**TECHNICAL BULLETIN**  
**Bell Helicopter** **TEXTRON**

No. 407-05-72

**SUBJECT:** Bearing Support 407-030-009-103,  
407-030-010-101, 407-030-831-105 and  
407-030-832-101, Primer- Application of

**Figure 1 Area on bearing support where the primer is to be removed  
 (sheet 1 of 1)**

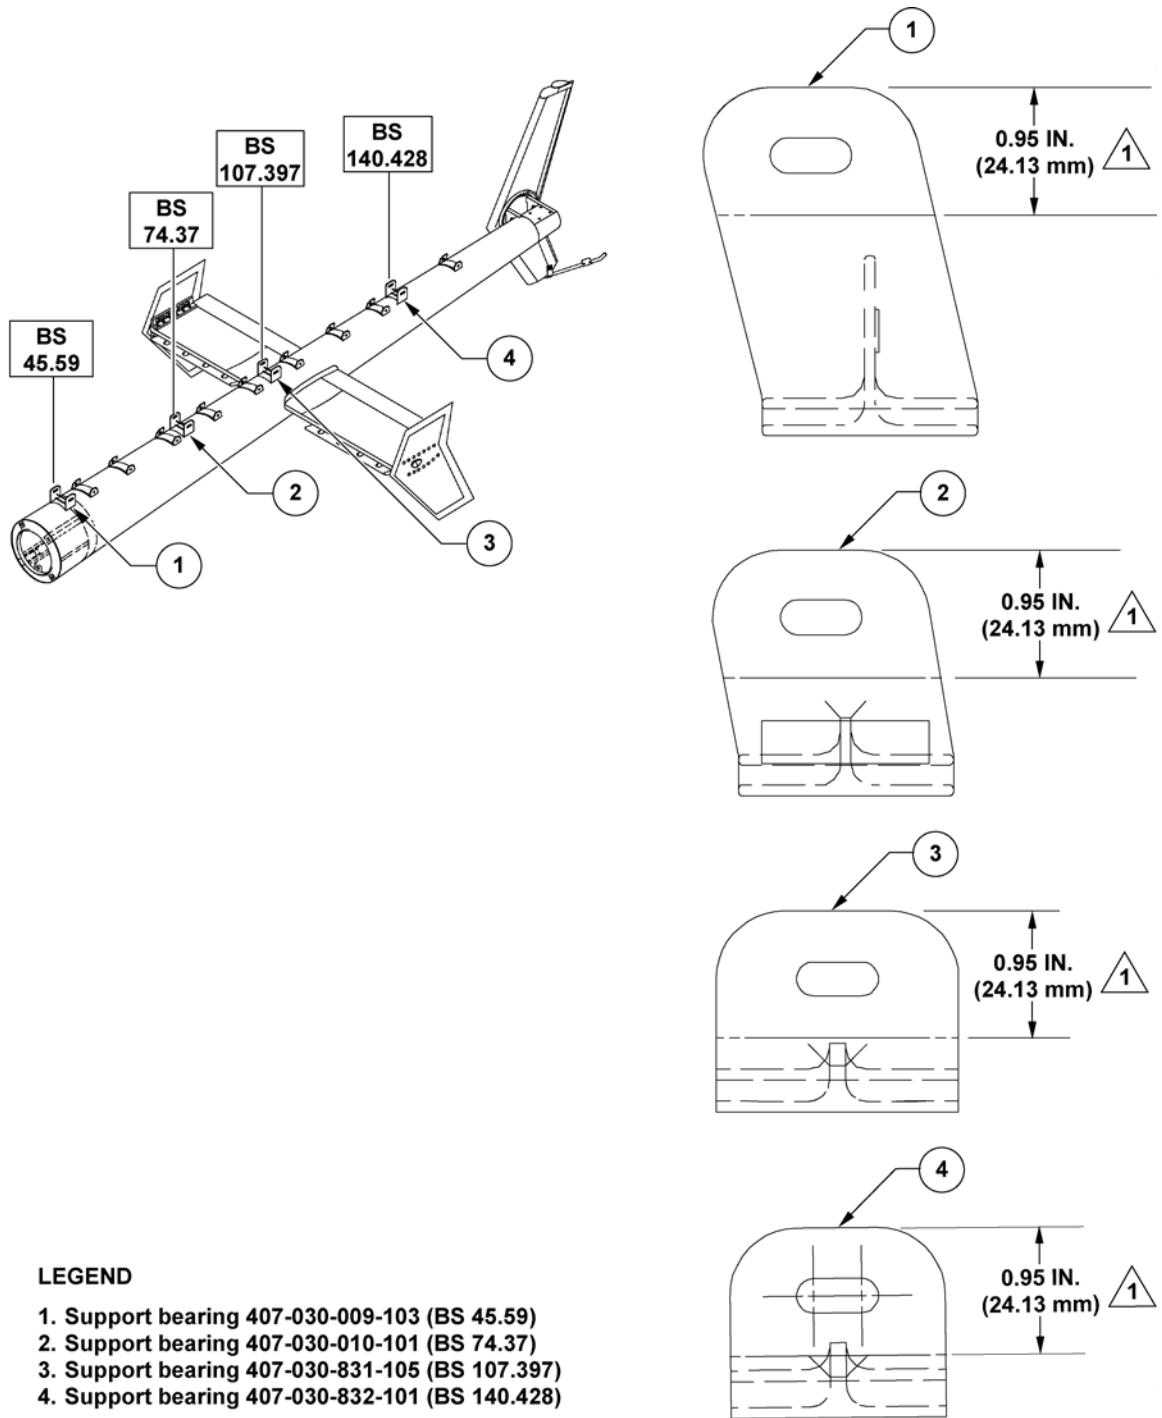
It has been determined that primer applied on bearing supports 407-030-009-103, 407-030-010-101, 407-030-831-105 and 407-030-832-101, could affect the bearing 407-340-339-107 alignment procedure.

This bulletin gives instructions to remove only the primer that is in contact with the bearing hangers 407-040-322-103.

3. Remove primer at specific location only on bearing supports (1,2,3,4, figure 1). Refer to BHT-ALL-SPM, Chapter 3, Plastic Media Blasting or Chapter 4, Paint Remover and Strippers.
4. Install the Aft Short Shaft Assembly and the Tail Rotor Drive Shaft Segmented Assemblies. Refer to BHT-407-MM-7, Chapter 65.
5. Install the Aft Engine Fairing Assembly, the Tail Rotor Drive Shaft Assemblies and the Tail Rotor Gearbox Fairing Assemblies. Refer to with BHT-407-MM-5, Chapter 53.
6. Annotate the aircraft technical records to indicate that this Technical Bulletin has been accomplished.

Remove organic finish as indicated, both sides of flanges and slots over entire area, 2 places.
